INSPECTION REPORT

Inspection Date:	02/23/2021	
Time:	Entry: 8:30 a.m.	Exit: 10:20 a.m.
Media:	Water	
Regulatory Program:	CWA NPDES/Construction Stormwater	
Operator Name(s):	M3 ID Rising Sun, LLC – (Notice of Intent IDR1002CM)	
Operator Addresses:	4087 West River Street, Suite 310	
Operator City, State, Zip Code:	Boise, Idaho 83702	
Site Name:	Rising Sun Subdivision	
Site Physical Location:	2067 East Kuna Road, Kuna, Idaho	
	Latitude/Longitude	43.4864°N, 116.3877°W
City, State, Zip Code:	Kuna, Idaho 83634	
Site Contact(s):	Mark Tate, Project Manager Phone: (208) 631-2025 Email: MTate@M3CompaniesLLC.com	Conger Management Group/M3 Companies, LLC
County:	Ada County, Idaho	
Site Identifier:	Rising Sun Subdivision	
Estimated Site Area to be Disturbed:	45.5 acres	
Site Receiving Water(s)	Indian Creek, New York Canal, Unnamed Waterway	
Site Receiving Water(s) Description:	Creek, canal	
NPDES Permit:	2017 EPA Construction General Permit (CGP)

Rising Sun Subdivision
Construction Stormwater Inspection Report

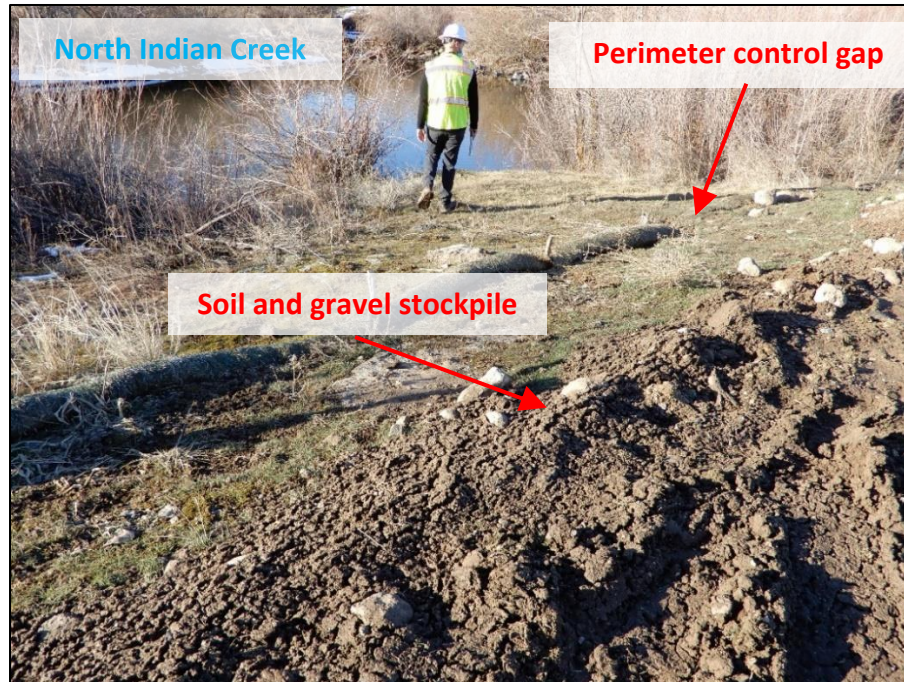
We observed eight locations of unstabilized stockpiles of soil, gravel, and rock—two locations at the north-central area of the Site, four locations at the center of the Site, one location at the south-central area of the Site, and one location at the southwestern perimeter of the Site (refer to Attachment A, Photographs 1 through 5). Downgradient of the stockpiles, sediment barriers of silt fences and fiber rolls were observed along the southern perimeter of the Site, except at the stockpile located at the southwestern perimeter of the Site that lacked sediment controls on the downgradient area (see Area of Concern 5 for further details) (refer to Attachment A, Photograph 5).

We observed a location that lacked perimeter control downgradient of an unstabilized stockpile of soil and gravel on the southwestern perimeter of the Site that was adjacent to North Indian Creek (refer to Attachment A, Photograph 5). No signs of discharge were observed downgradient of the perimeter gap in North Indian Creek.

Photograph 11. Another view, facing north, of a collapsed silt fence along the Site's southern perimeter as shown in [Photograph 10](#). Note the erosion to the north of the collapsed silt fence.

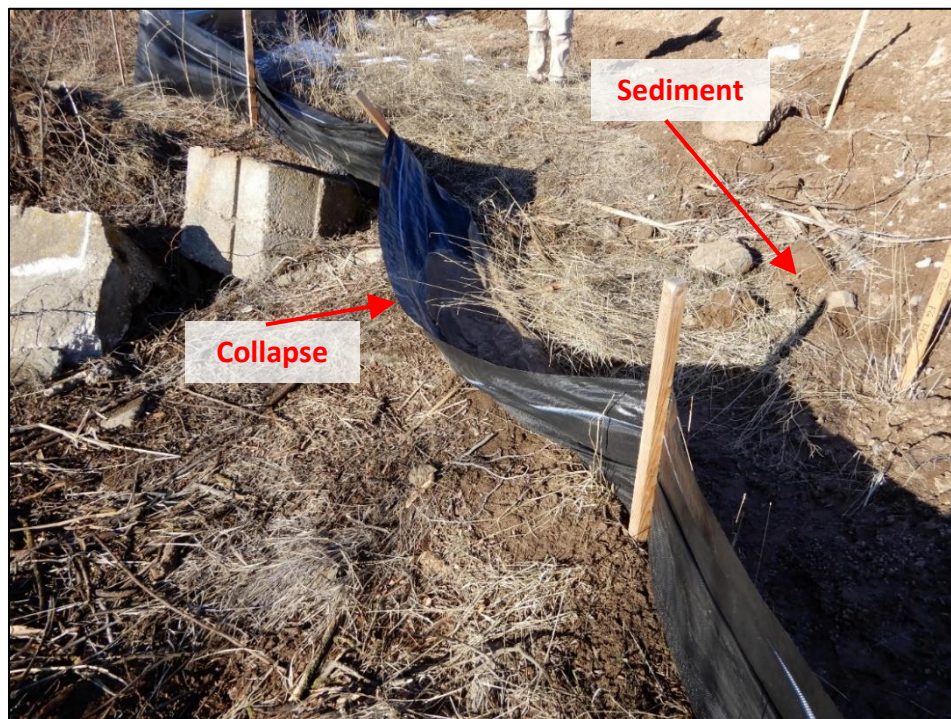
We observed a location along the silt fence located at the south-central area of the Site that had collapsed with visible signs of erosion in the surrounding soil and evidence of discharge downgradient to North Indian Creek. At the time of the inspection, no flow was observed. Sediment had accumulated adjacent to the collapsed silt fence (refer to Attachment A, Photographs 10 through 12). Site Representatives stated that they had not conducted turbidity testing on discharge at this location or at any time in the history of the Site's operation. We observed turbidity both upstream and downstream of the potential discharge location in North Indian Creek; therefore, we were unable to determine if runoff had discharged at the location and if it had contributed to the creek's turbidity (refer to Attachment A, Photographs 13 through 16). It was, however, noted that North Indian Creek seemed to be receiving turbid runoff

Exhibit 2. Image of the Site map provided on Site of Rising Sun Subdivision. It was noted that the Site map does not identify locations of stockpiles and that the labeled Site perimeter controls were not reflective of the Site conditions at the time of the inspection.

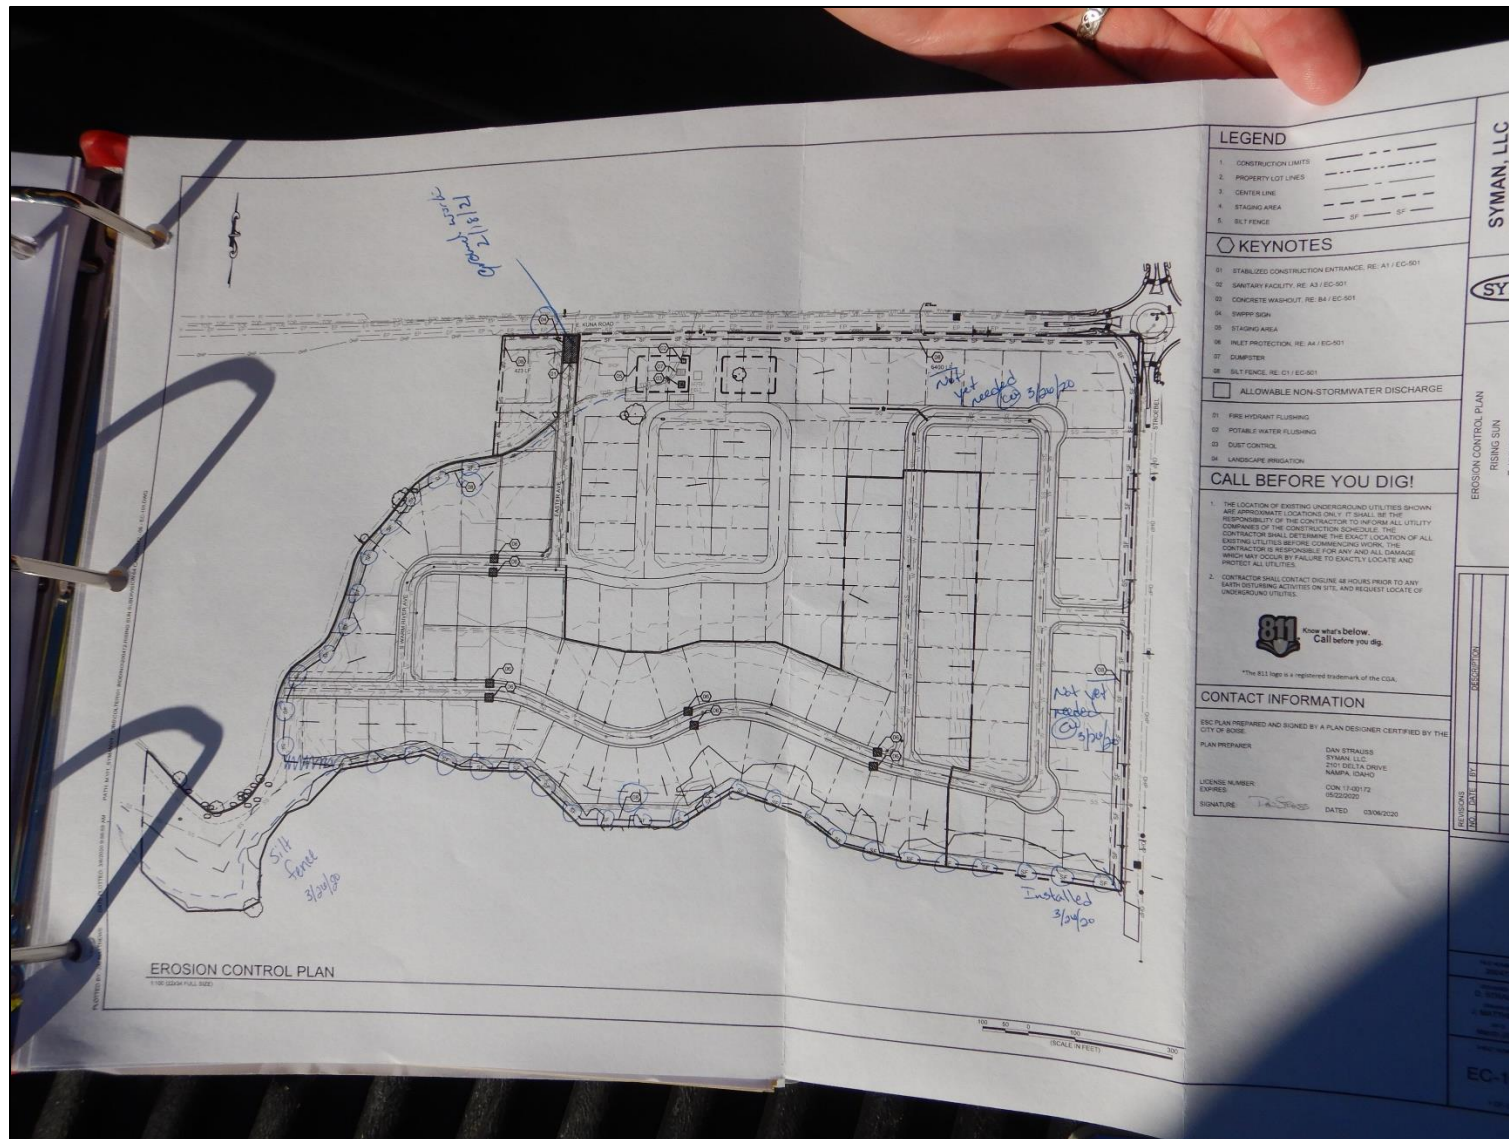
During the onsite records review, we observed that the SWPPP map presented onsite did not include locations where sediment and soil would be stockpiled as required by part 7.2.4.b.iii of the Permit. The Site had eight locations where soil, gravel, and rock were stockpiled – two locations at the north-central area of the Site, four locations at the center of the Site, one location at the south-central area of the Site, and one location at the southwestern perimeter of the Site (refer to Attachment A, Photographs 1 through 5 and Attachment B, Exhibit 2).

We also observed that the SWPPP map presented onsite did not identify all stormwater controls used as Site perimeter controls as required by part 7.2.4.i of the Permit. The SWPPP map labeled all southern perimeter controls as silt fences. We observed both silt fences as well as fiber rolls as the Site's southern perimeter controls (refer to Attachment A, Photographs 6 and 7 and Attachment B, Exhibit 2). Additionally, we did not observe silt fences on the western, eastern, and northern perimeters of the Site as labeled on the SWPPP map.
